APPLICATION NO.	FILING DATE	FIRST NAMED INVENTOR	ATTORNEY DOCKET NO.	CONFIRMATION NO.
10/754,032	01/08/2004	Michael Weiss	WET 0122 PUS	6079

Office Action Summary	Application No. 10/754,032	Applicant(s) WEISS, MICHAEL	
	Examiner Vinh T Luong	Art Unit 3682

1. The drawings are objected to because:

FIG. 3

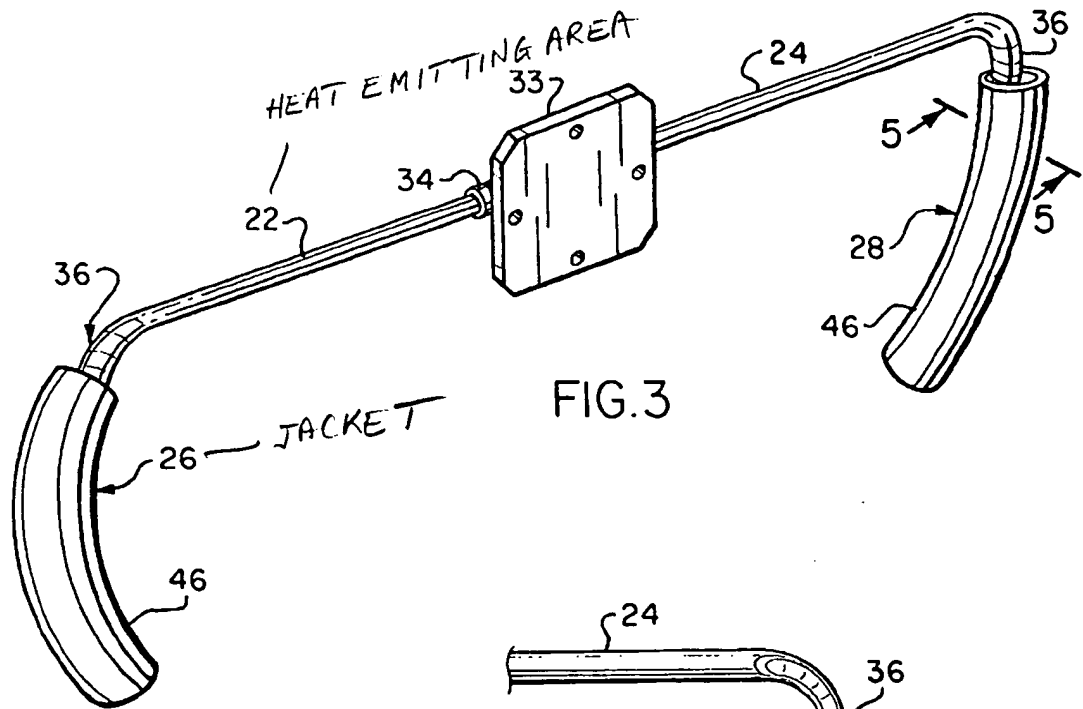
Regarding claim 1, Feher teaches a steering device 12 comprising a cooling device 10 arranged therein, the cooling device 10 comprising at least one heat pipe including at least one heat-absorbing area 36 (Fig. 3) and at least one heat-emitting area 22, 24, the at least one heat-absorbing area 36 being located in a grip region 16, 18 of the steering device 12. *Id.*, Figs. 1-10 and claims 1-17.

Regarding claim 17, the heat pipe comprises a closed tube having a transport device lining at least a portion of the inner tube wall and defining a fluid volume in the heat-absorbing area 36 and a fluid and gas-exchange volume in the heat-emitting area 22, 24 of the cooling device 10 as seen in Fig. 3.

FIG. 4

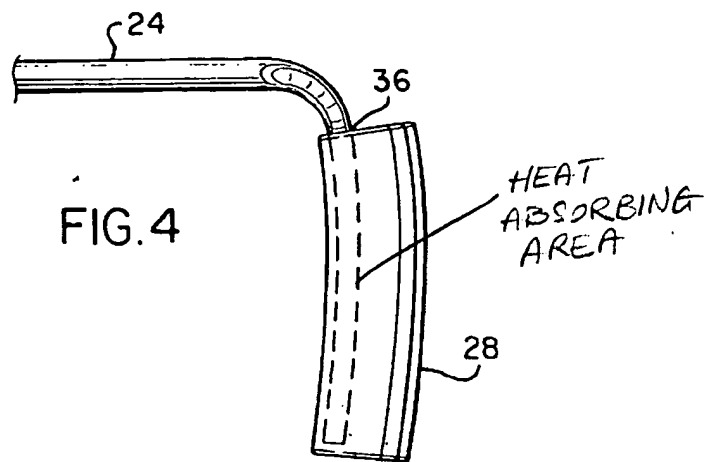
Regarding claim 15, Feher teaches a steering wheel comprising a toroidal grip portion 46 comprising a rigid core (Fig. 5, see Attachment) surrounded by a jacket 26, 28; a center portion (at 38 in Fig. 2) connected to the grip portion 46 by at least one spoke (at 42 in Fig. 2); and a cooling device 10 comprising a heat pipe including a heat-absorbing area 36 arranged in at least part of the grip portion 46 and a heat-emitting area 22, 24 arranged in at least part of the center portion (Att.).
